# **US-APWR DCD Revision 2 RAI Tracking Report**

**March 2010**

This report includes a table that identifies the impact of each response to the Request for Additional Information (“RAI”) relative to the Design Control Document (“DCD”) Revision 2 of US-APWR. This table shows the RAI responses which have been submitted since October 2009 and also should be incorporated into Tracking Report and DCD in future revision.

Figure 3.8.1-13 Transient Conditions of Temperature of the **Refueling Reactor** Cavity Atmosphere and Sump Pool Water (Pipe Break in the **Refueling Reactor** Cavity)

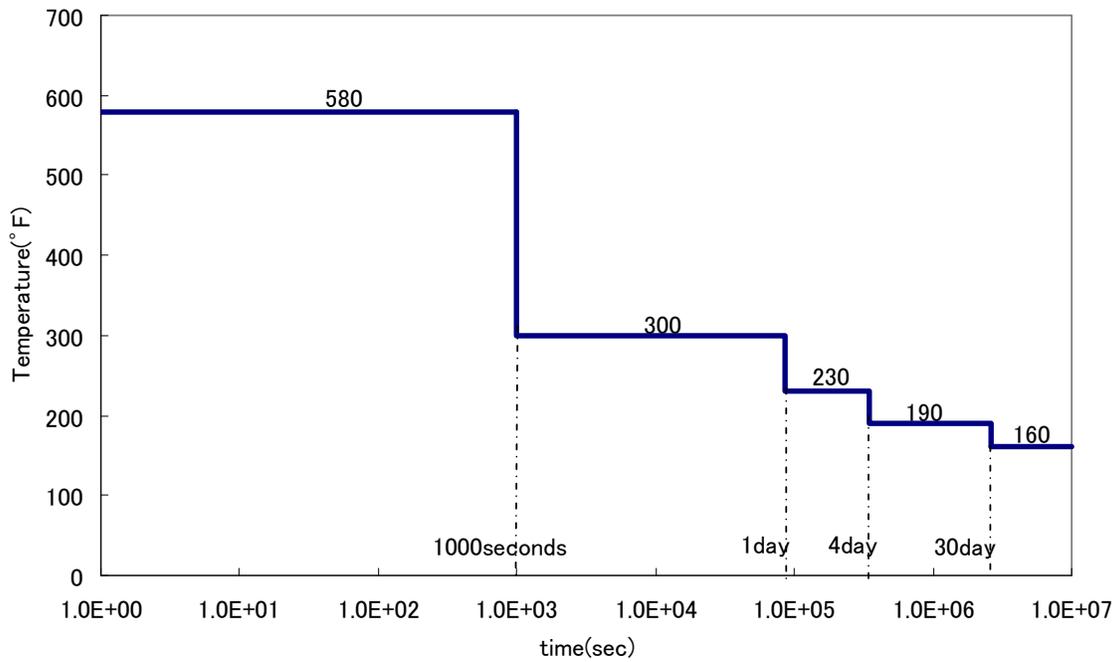
3.8-163	Figure 3.8.1-13 Figure Title	Change: “Transient Conditions of Temperature of the Refueling Cavity Atmosphere and Sump Pool Water (Pipe Break in the Refueling Cavity)” to “Transient Conditions of Temperature of the Reactor Cavity Atmosphere and Sump Pool Water (Pipe Break in the Reactor Cavity)”  Reason: Correct typographical error

Figure 19.1- 20 Loss of Offsite Power Event Tree

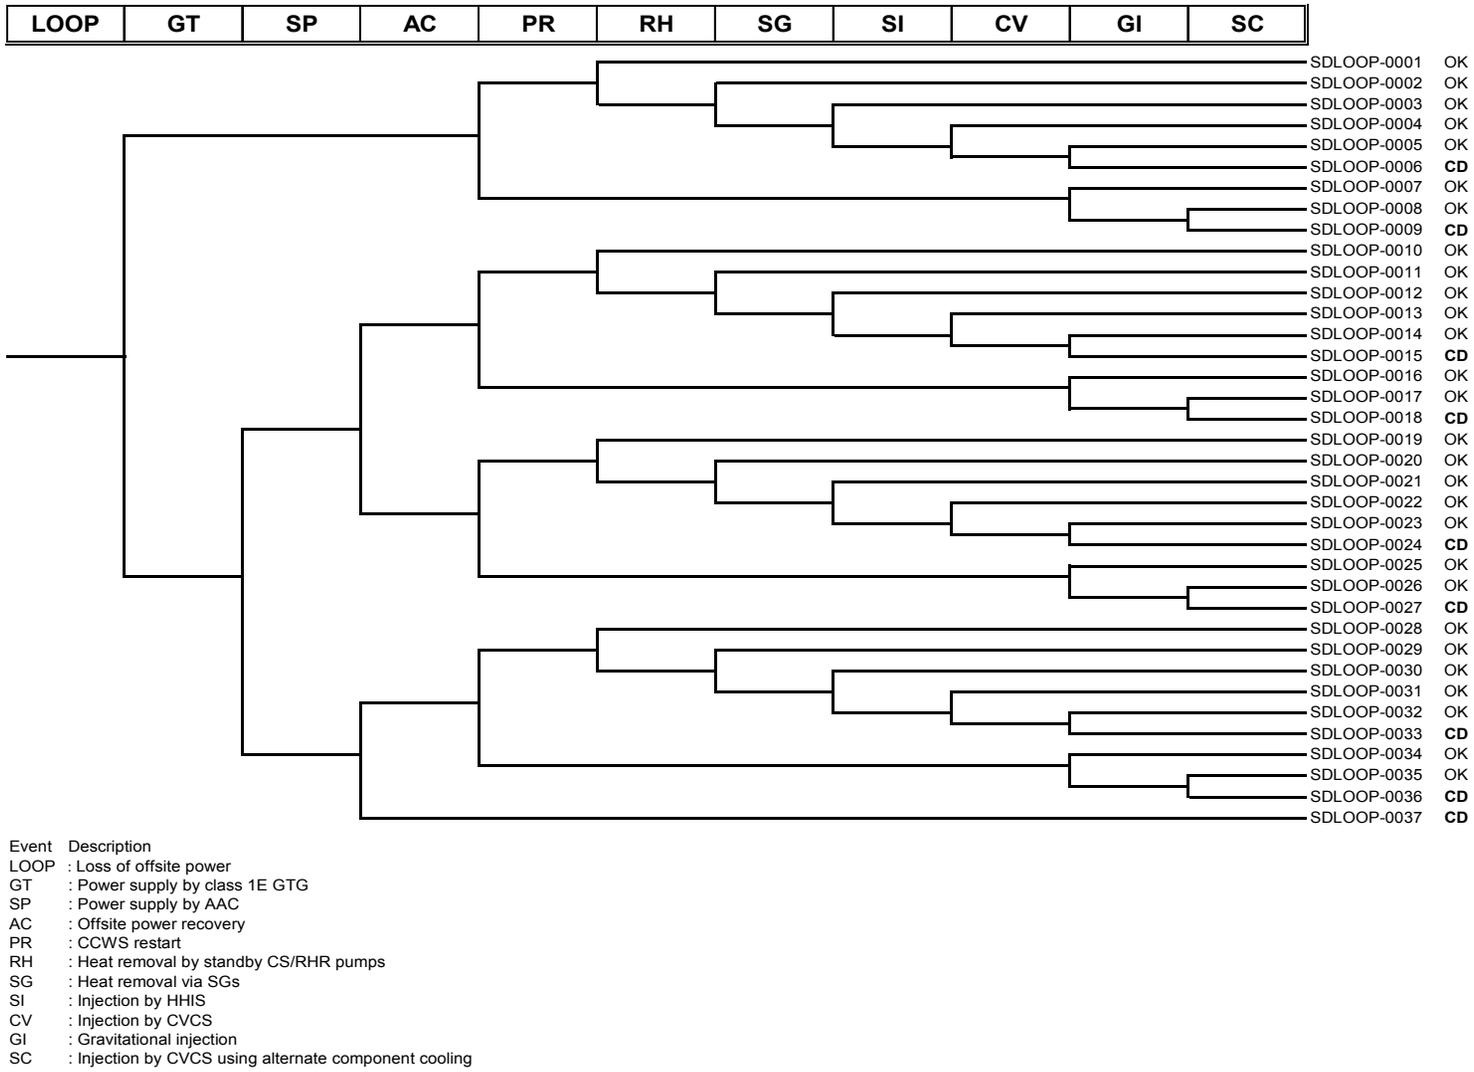
19.1-1078	Figure 19.1-20	RAI#528 19-419 Changed the loss of offsite power event tree figure to the one that has been revised associated with change in loss of offsite power initiating event frequency.
